INSTRUCTION TO SERVICE

ITS-60877		12/05/2023
SECTION:	260 - Battery Compartment	
WRITTEN BY:	Michael Rooney	
SUBJECT:	Relocate rear impact sensor in baggage bay three.	
ISSUE:	Luggage in the baggage bay can cause the impact sensor to activate.	
SUMMARY:	Relocate the impact sensor and wiring.

Figure 1: Existing Accelerometer & Accelerometer Harness Installation.

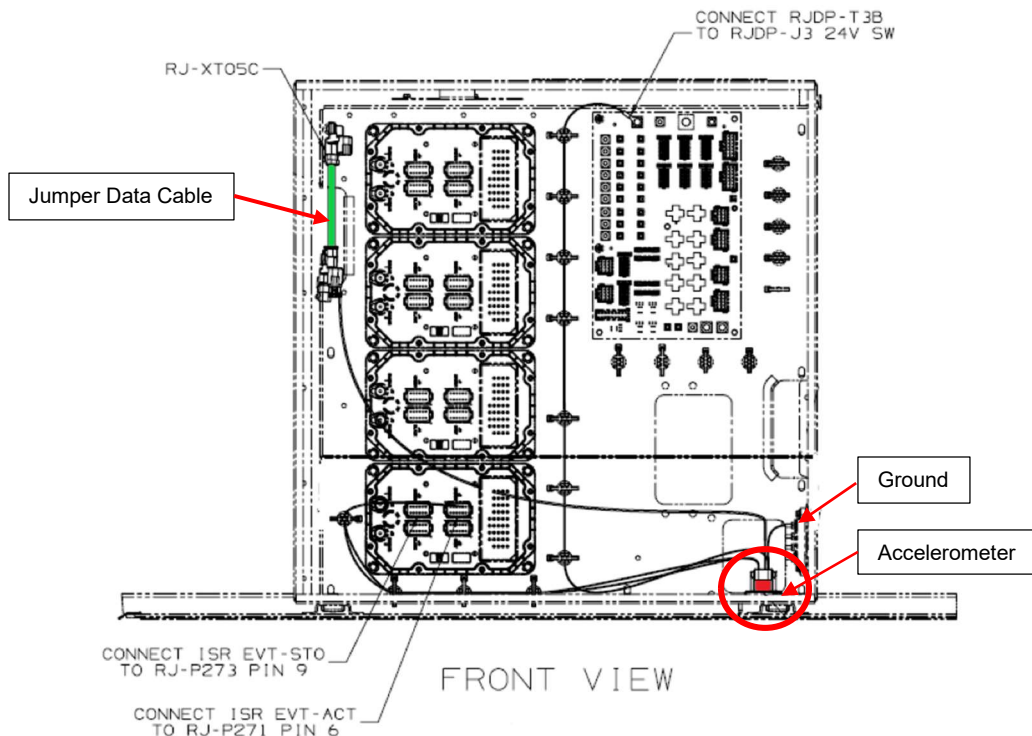
5. Locate the accelerometer at the bottom street side of the Junction box.
 - a. Disconnect the 8 pin electrical connector at the accelerometer.
 - b. Remove the screws used to secure the accelerometer then remove the accelerometer and set it and the mounting screws aside.

6. Remove the accelerometer harness from the junction box.
 - a. Disconnect the Jumper Data Cable at the Accelerometer Harness then remove the Jumper Data Cable and set it aside.

- b. Disconnect the accelerometer harness ground wire at the terminal block next to where the accelerometer was previously installed.
 - c. Disconnect the accelerometer harness wire coded RJDP-T3B at RJDP-J3.

- d. De-pin the accelerometer harness wire coded ISR EVT-STO at RJ-P273 Pin #9.
 - e. De-pin the accelerometer harness wire coded ISR EVT- ACT at RJ-P271 Pin #6.

- f. Remove the accelerometer harness from the Junction box.

Figure 2: New Accelerometer Mounting Location.

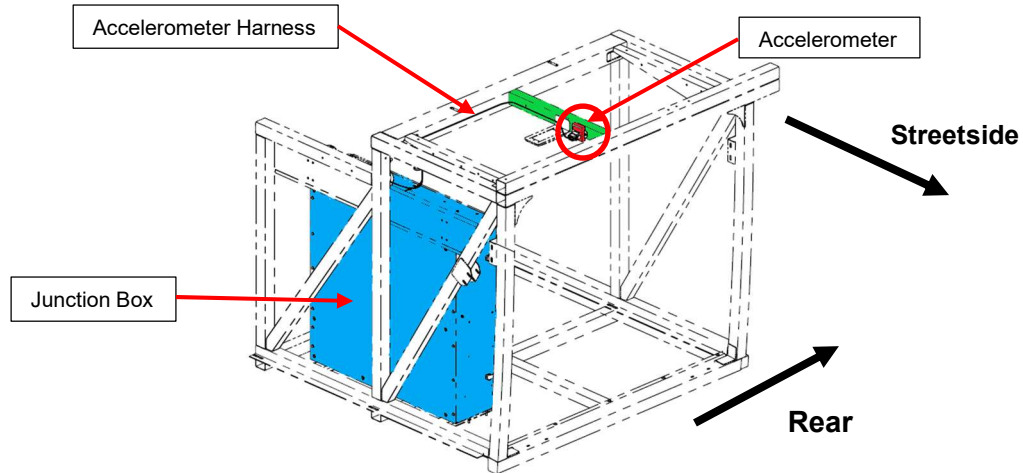
7. Locate the transverse frame member at the top of the baggage bay near the center on the curbside. Figure 2.

9. Plug the 8 pin connector on the accelerometer harness P/N 1039406 into the accelerometer.
10. Route the accelerometer harness along the existing harnesses to the junction box as seen in Figure 2.
Secure the harness as needed with tyrapas NF P/N 5958112.

Figure 3: Drilling Locations for Accelerometer Mounting Screws.

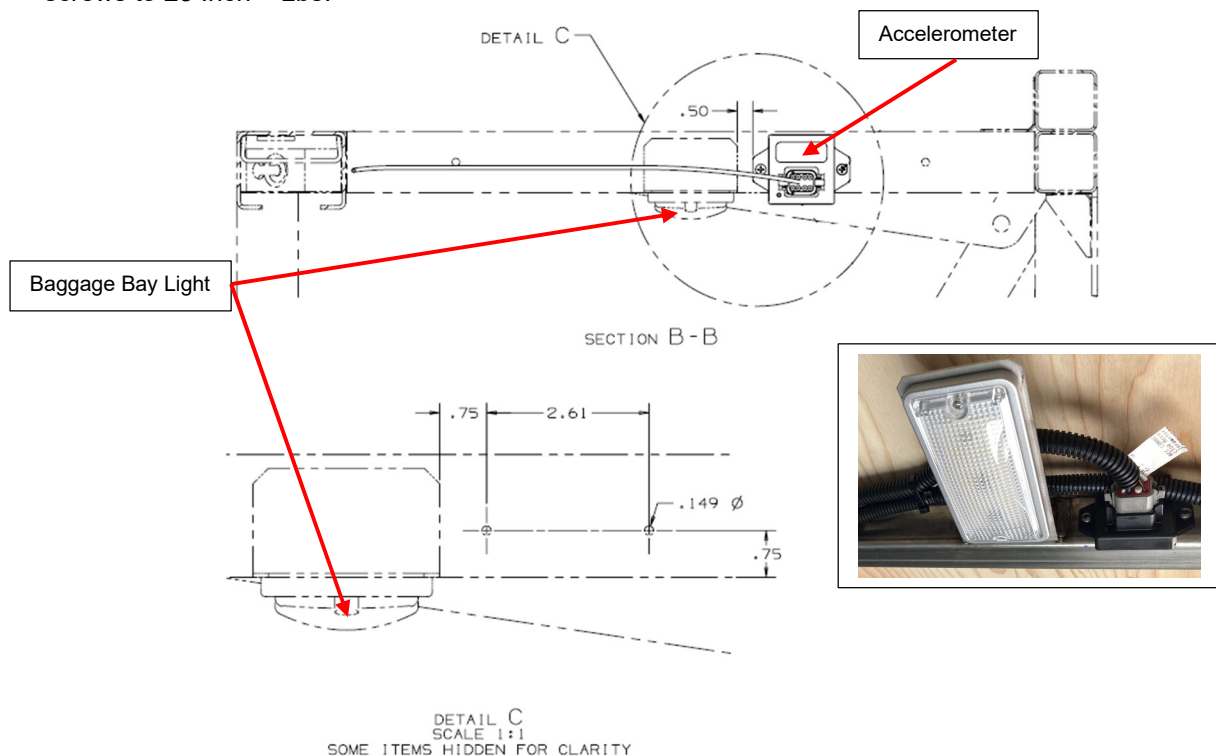
8. Drill two 0.149" Dia mounting holes in the forward face of the frame member at the locations shown in Figure 3.
- a. Mount the accelerometer removed and set aside earlier to the frame member using the original mounting screws set aside earlier. Orient the accelerometer such that the LED light is pointed downward. Torque screws to 23 Inch – Lbs.

Figure 4: New Accelerometer Harness Installation in Junction Box.

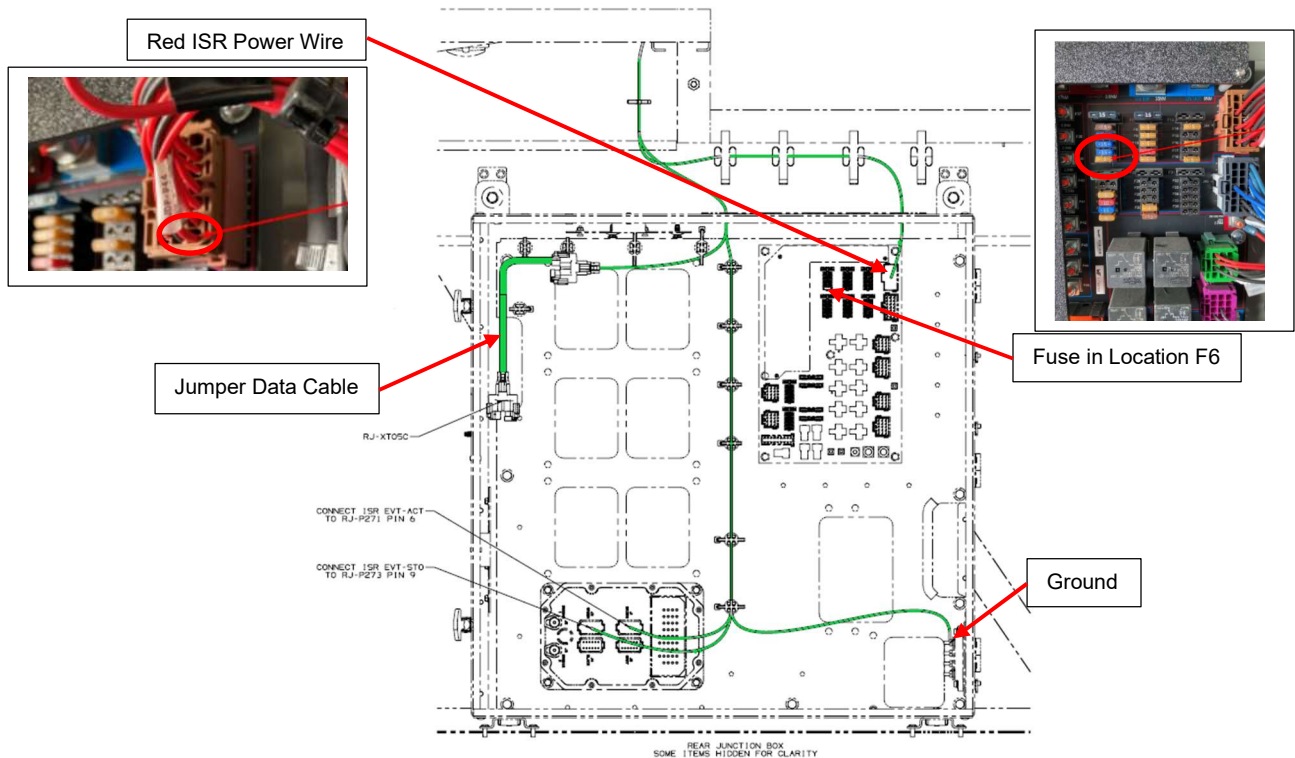
11. Inside the junction box, route the harness as seen in Figure 4.
 - a. Reinstall the Jumper Data Cable removed earlier. Connect the end of the Jumper Data Cable to the “T” Connector on the Accelerometer harness. Connect the other end of the Jumper Data Cable to RJ-XT05C.

- b. Connect the ring terminal on the ground wire of the accelerometer harness original ground location on the terminal block next to where the accelerometer was previously located.

- c. Install the pin on the wire coded ISR EVT - STO in the RJ - P273 Pin #9 connector location.
 - d. Install the pin on the wire coded ISR EVT – ACT in the RJ – P271 Pin #6 connector location.

- e. Install a 5A fuse NF P/N 07-08-1057 in location F6 on the distribution board.
 - f. Install the pin on the wire coded ISR Power in the RJDP-P44 Pin #3 connector location.

- g. Bundle the accelerometer harness with the existing harnesses and secure with tyrapas NF P/N 5958112.
